SKOKOMISH RIVER BASIN MASON COUNTY, WASHINGTON ECOSYSTEM RESTORATION

APPENDIX L

FISH AND WILDLIFE COORDINATION ACT FINAL REPORT

Subject: Final Fish and Wildlife Coordination Act Report, Skokomish River Basin
Ecosystem Restoration Project

Figure 7. Map showing proposed Car Body Levee removal area, area where South Fork will be diverted into the North Fork, and current and former (pre-2004) confluence of the North and South Forks of the Skokomish River.

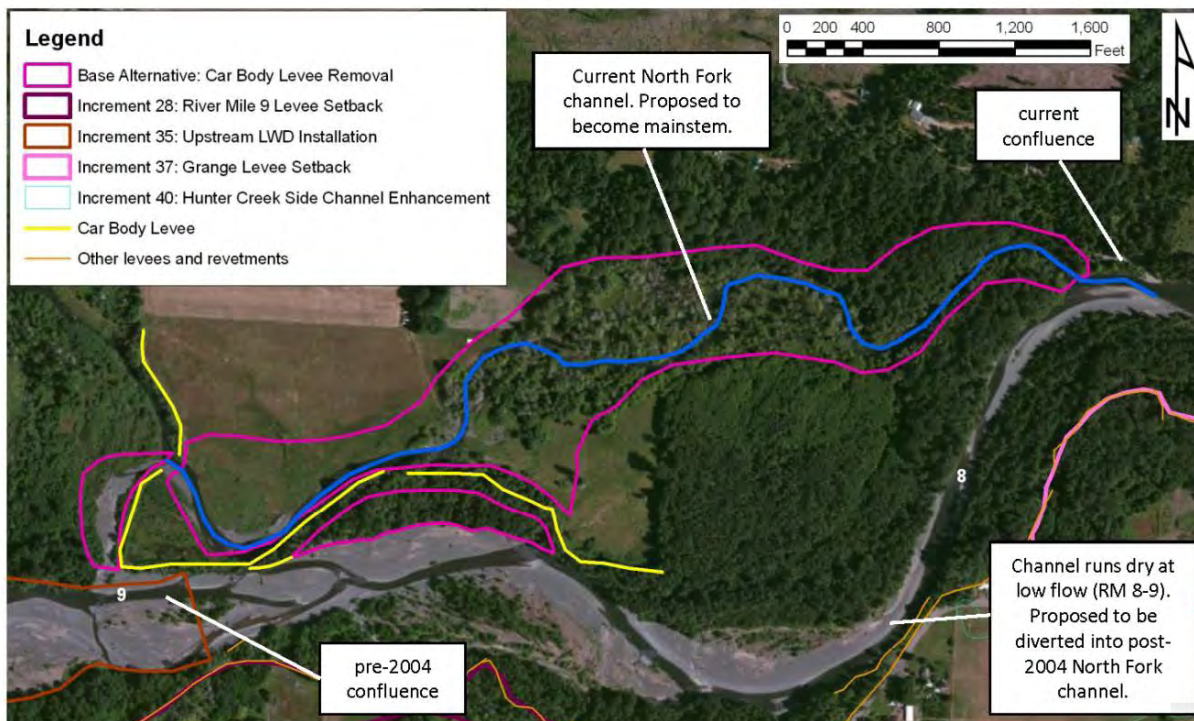
- *Car Body Levee Removal* - The Service identified potential negative effects of leaving existing levee sections in place, which was part of the Corps' initial proposal. The current proposal is to remove the entirety of the existing levee, thereby eliminating these concerns.

5. Benefits of the Car Body Levee removal may be maximized by incorporating enhancements to the North Fork channel between the old and new channel confluences (RM 7.8 to 9). The Service recommends evaluating this area for potential LWD additions, riparian planting, and other such enhancements.

Figure 8. Map showing proposed upstream LWD installation area (Increment 35). LWD jams and single logs will be placed in the channel and along the banks, although exact locations have yet to be proposed.

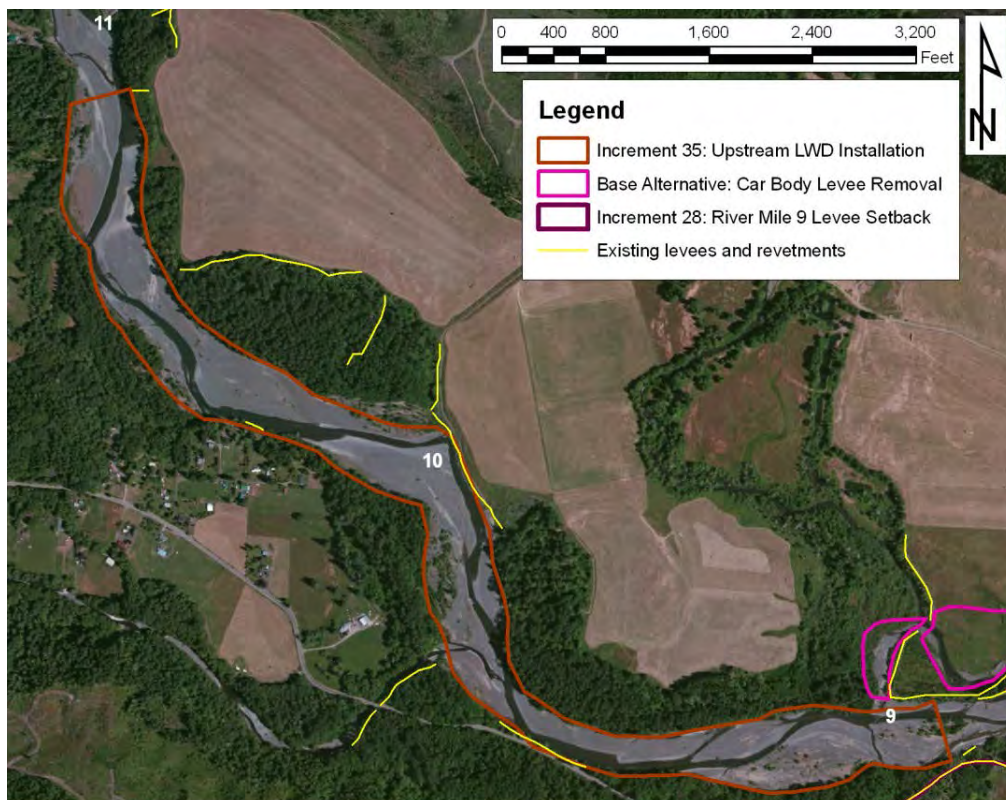
- *Upstream LWD Installation* - The Service identified potential negative effects associated with improper placement of ELJ's and large wood. Improper placement could serve to "lock" the channel in place rather than providing the intended geomorphic, hydraulic, and fish habitat benefits. The current Corps engineering design drawing (dated December 5, 2014) does not indicate any improper ELJ or large wood placements. These concerns are thus eliminated.

1. *Improper ELJ and large wood placement.* The current design does not indicate any improper ELJ or large wood placement. The Service encourages the Corps to remain attentive to this recommendation in making any modifications to the design and placement of ELJ's and large wood.

1. *Channel pattern, river mile (RM) 9 to 11.* The seven bar apex-type ELJ's the Corps has added to the project proposal will help facilitate formation of an island-braided pattern to this reach of the river. The Service further recommends intentionally locating the proposed five-log clusters to serve specific geomorphic functions, including: a) ensuring that flow is directed at the bar apex-type ELJ's; and, b) encouraging development of a meandering pattern and relatively deep, narrow channels throughout the reach. The meander jams described by Abbe and Montgomery (1996) are useful in providing these functions. A relatively deep, narrow channel will facilitate sediment transport through the reach, which will minimize future aggradation and provide better fish habitat.

Figure 12. Map showing proposed Hunter Creek side channel enhancement area (Increment 40).

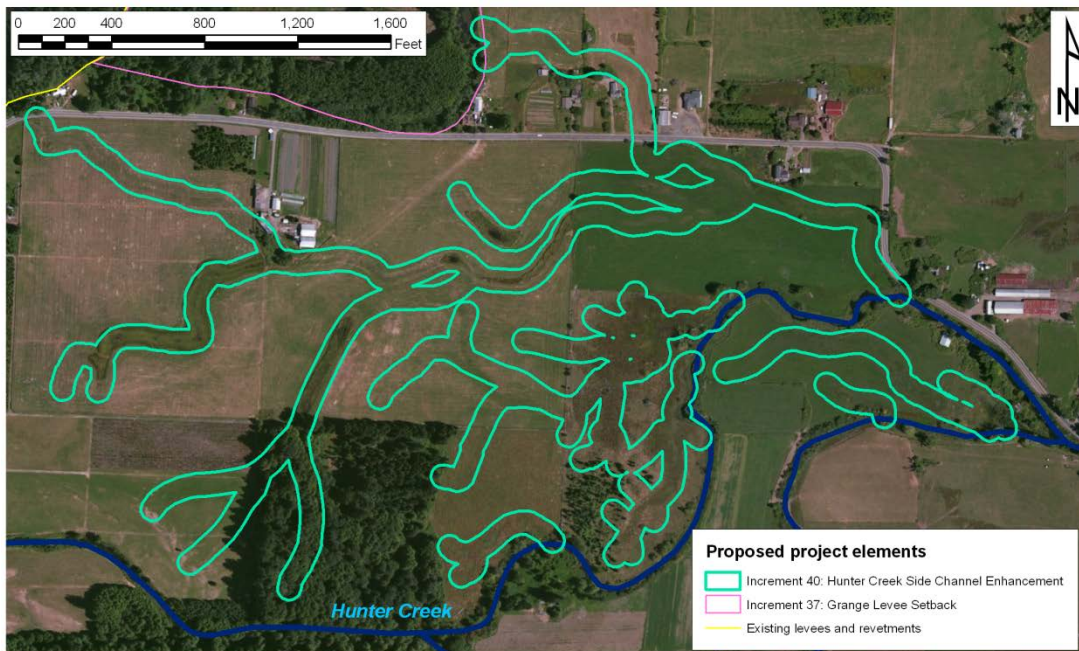
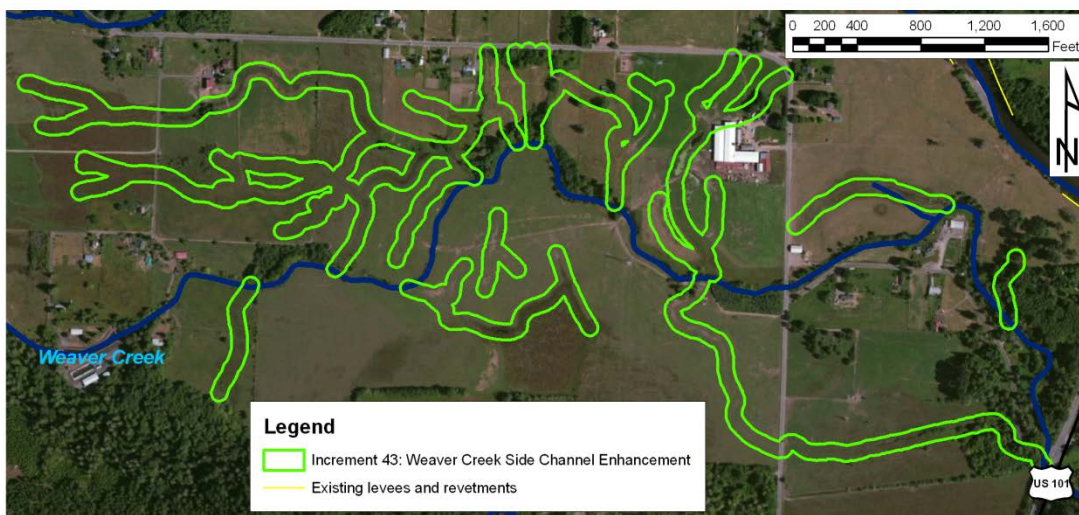
3. The Service does not support tributary side-channel enhancement designs (Increments 40 and 43) that do not include provisions for protecting water quality associated with runoff from the surrounding agricultural fields. This may be accomplished in various ways, including planting riparian buffers and in-channel vegetation, installing water control structures, and other measures (e.g., Evans et al. 2007; Needelman et al. 2007; Strock et al. 2010; Messer et al. 2012; Pierce et al. 2012).

4. The Service does not support designs for restoration and enhancement of tributary side-channels (Increments 40 and 43) that do not include provisions for maintaining or improving water temperatures. Riparian buffers that include native trees and woody shrubs provide shade that help maintain cool summertime temperatures, as well as provide added habitat and water quality protection benefits.

5. The Service does not support designs for restoration and enhancement of tributary side-channels (Increments 40 and 43) that result in homogenous and featureless channel forms that lack complex habitat elements. To the greatest extent practical, tributary side-channels should include abundant in-stream structures (LWD) and be designed in a manner that provide heterogeneity in flow regimes (areas with flowing water channels and blind channels with no flow), morphology (varied depths; pools and riffles), and substrate (gravels, cobbles, silt, etc.). Channels exhibiting such diversity and complexity would maximize fish utilization and rearing densities. Complex and diverse channels and instream habitat features would also minimize predation risk on rearing or refuging juveniles. Failing to incorporate sufficient structure, diversity, and complexity may result in negative impacts and consequences that outweigh any realized benefits.
